Enclosed are three (3) documents to be included in the Administrative Record file for the Operable Unit 1: 881 Hillside Area project. The three documents are public comments on the proposed Major Modification to the OU1: 881 Hillside Area Corrective Action Decision/Record of Decision, dated May 2000, received from the City of Broomfield, City of Westminster, and Man-In-The-Maze Consulting. No other public comments were received.

Re: Major Modification to Operable Unit 1 (OU1): 881 Hillside Area

SUBJECT: Comment on Major Modification to Operable Unit 1: 881 Hillside Area

OU 1 Collection Well Trichloroethene Concentrations

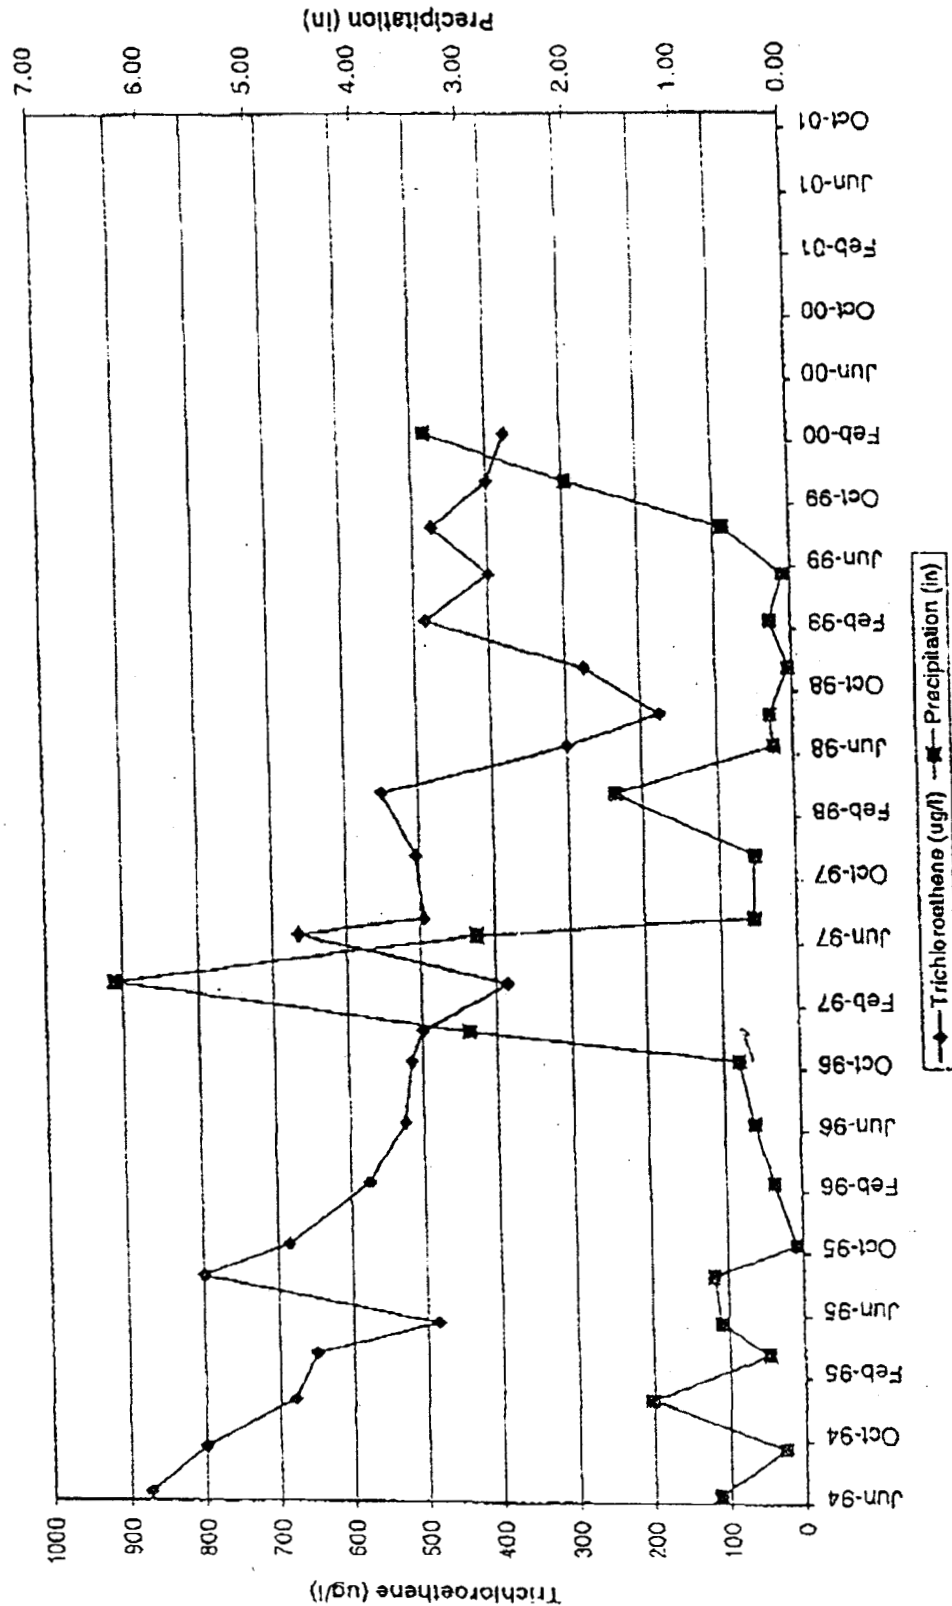
- Attached graph #1, prepared by City Staff using DOE data, shows the relationship between Trichloroethene concentrations and precipitation at Rocky Flats. It appears that there are higher concentrations during periods of low precipitation. Although the February 00 concentration data point goes down below 400 ug/l after the October 99 precipitation event of 3.5 inches of rain, there is not enough additional information to indicate that there is indeed a downward trend of TCE in the OU1 Collection Point.

Comparison of Precipitation vs. Trichloroethene

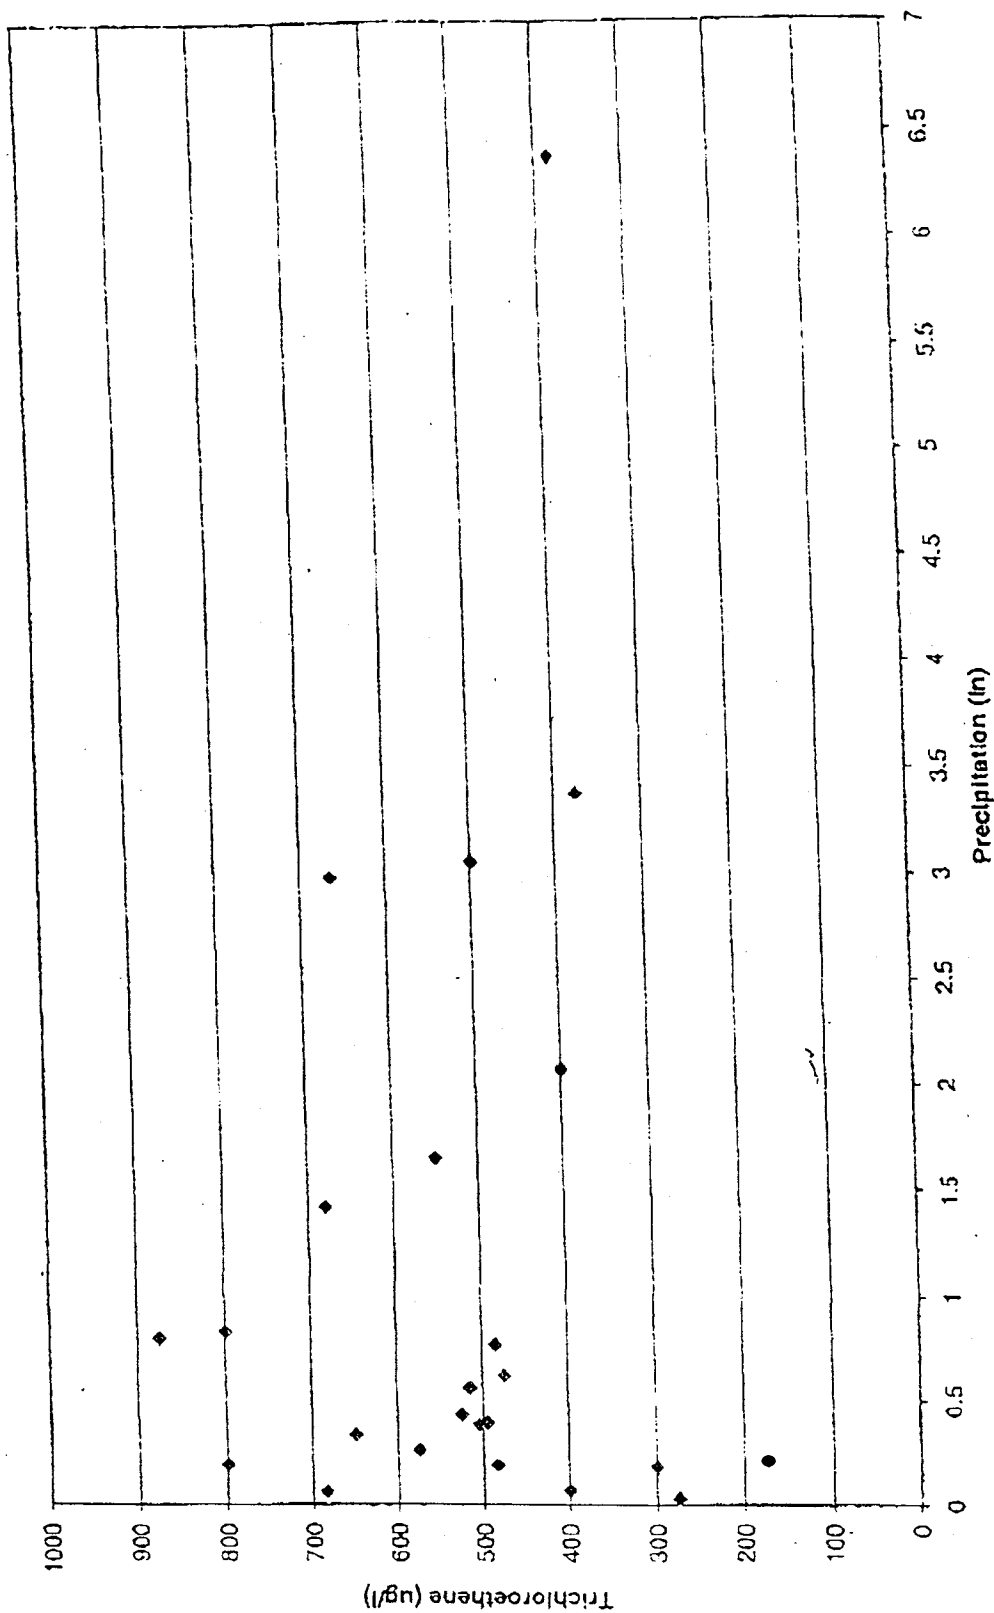
- Attached graph #2 provides a correlation of precipitation vs. Trichloroethene data points. Most of the data points are concentrated in the area of 0.5 to 1 inches of precipitation, which is the usual annual amount of precipitation for this area. It would seem that data from a normal precipitation year would provide a much stronger indicator that there was indeed a downward trend.
